## **Fire Risk Assessment**

**Tobacco Warehouse Block B  
Commercial Road  
Liverpool L5 9XB**

**Date: 5th November 2019**

Tobacco Warehouse, Block B,  
Commercial Road,  
Kirkdale, Liverpool L5 9XB

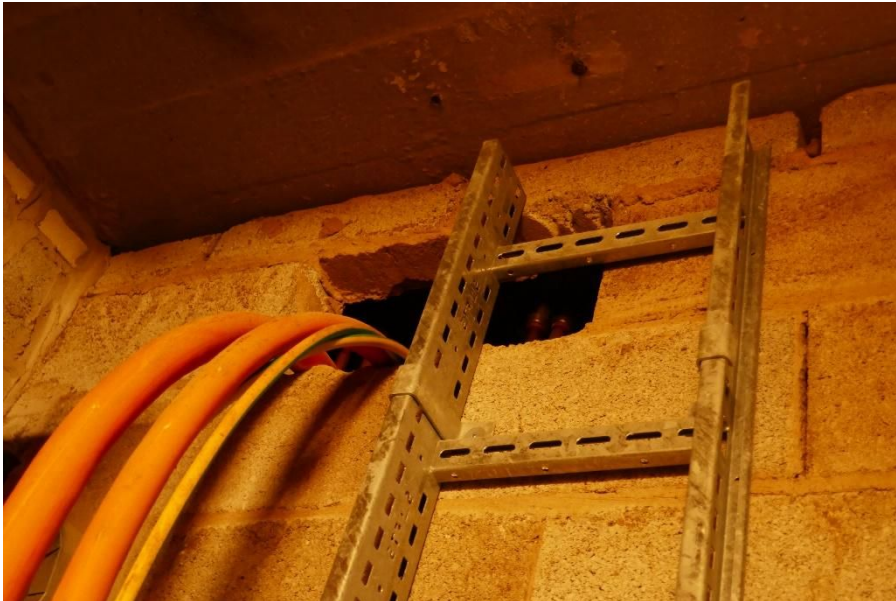
Basement Area store, all waste to be removed
